**585 Third Street
Cambridge, Massachusetts**

PB-383

PUD Special Permit Presentation

January, 2022

Landscape Plan - Athenaeum Street

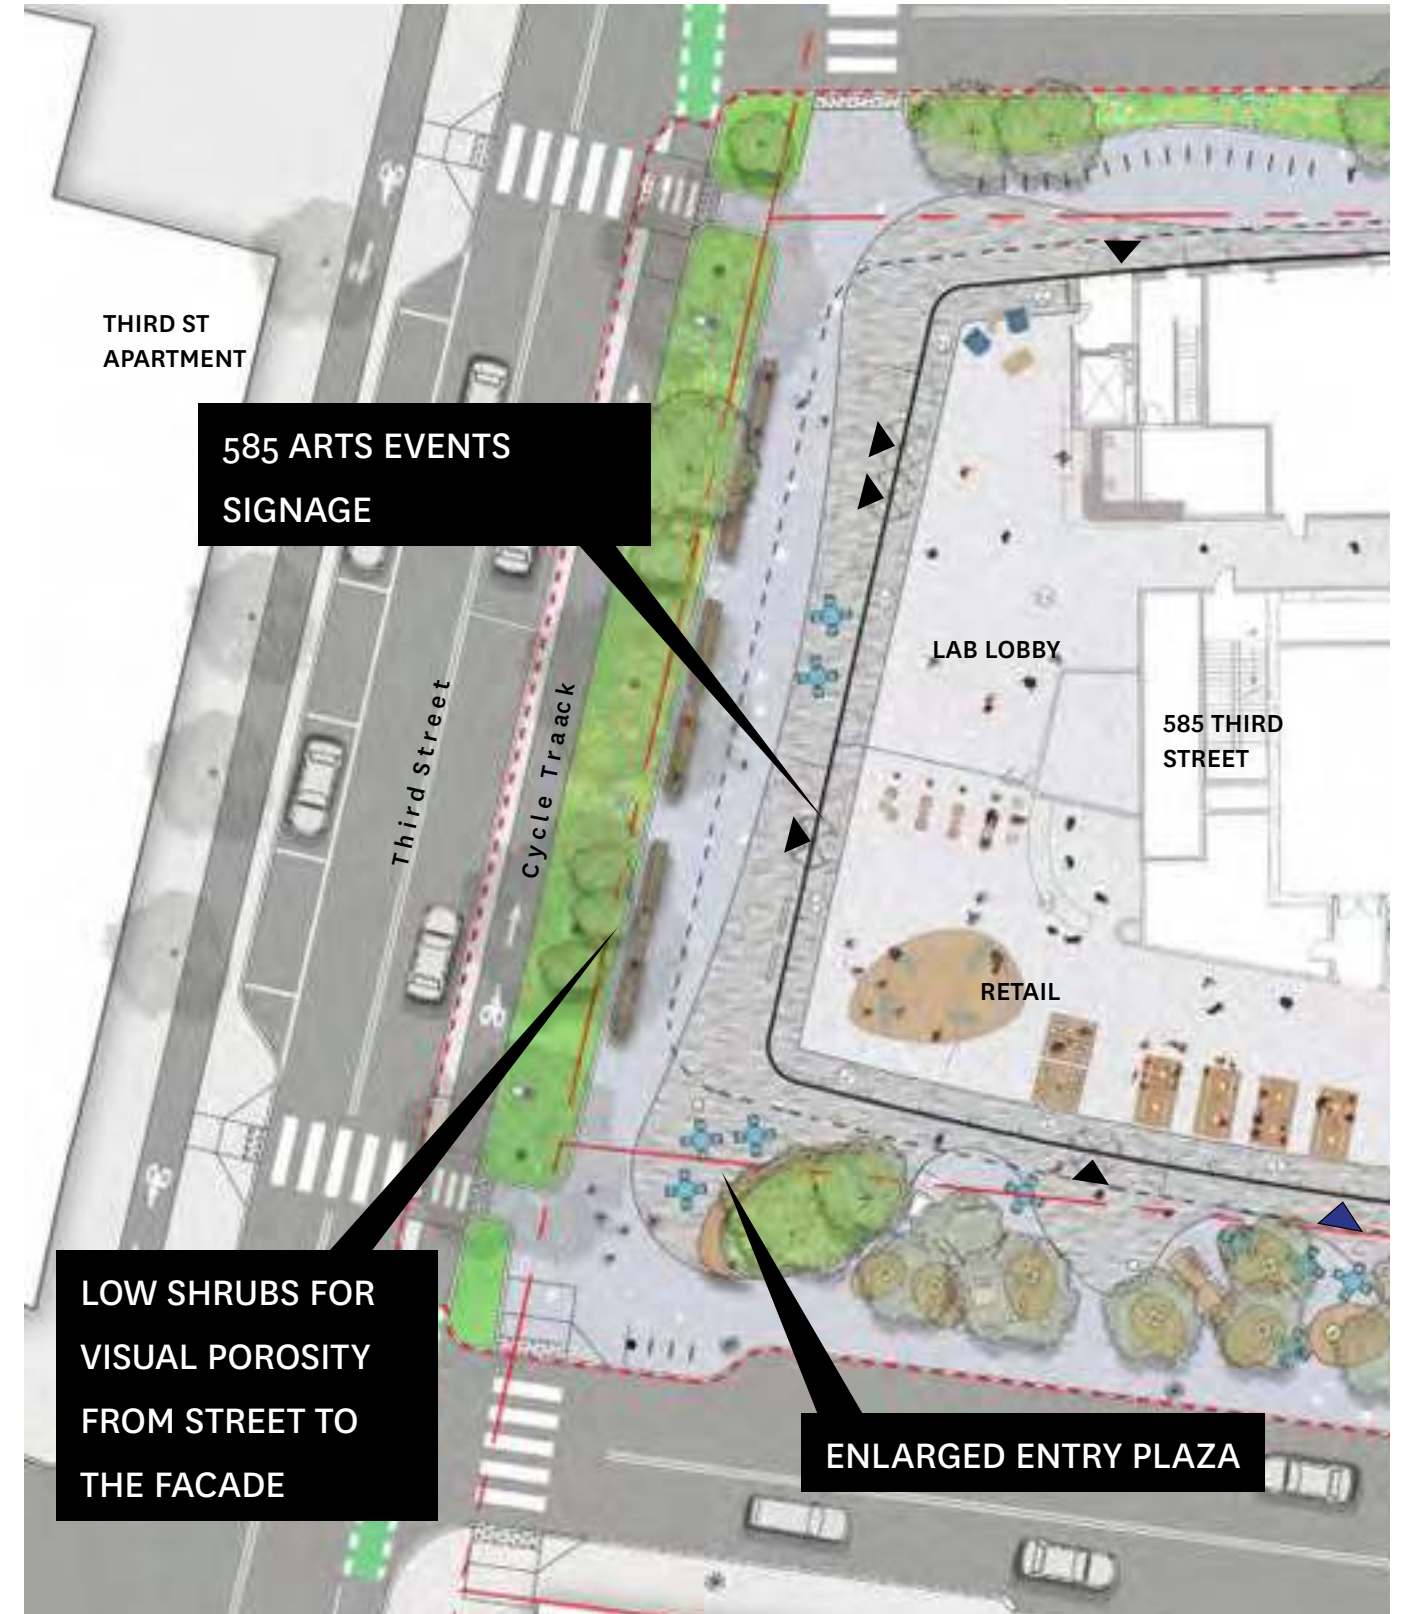
- More information about the proposed oval planting beds, and opportunities to redesign them so as to avoid creating physical and visual barrier between the public realm and the ground floor of the building.
- More information related to the proposed character of each landscape/open space zone, including opportunities to integrate public art and play for both children and adults.
- Landscape plans for the upper story terraces.
- Clarification of the landscape views provided in the building renderings as they appear to be different.

ADDITION OF BIKE REPAIR
STATION

Theater Drop-off Logistics Plan

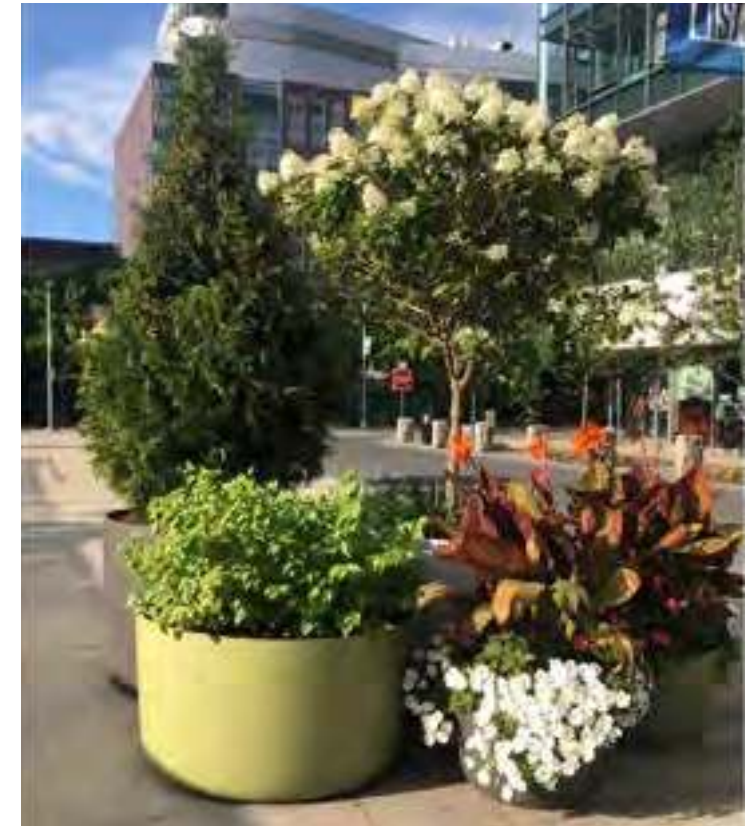
- Opportunities to provide landscaping (low in height) around the proposed Bluebikes station.
- Opportunities to provide publicly accessible bike air pumps and repair tools.
- Address Theater drop off logistics.

-  Pick-up/drop-off Passenger Route
-  Pedestrian Route
-  Bicycle Route
-  TNC Vehicle Route
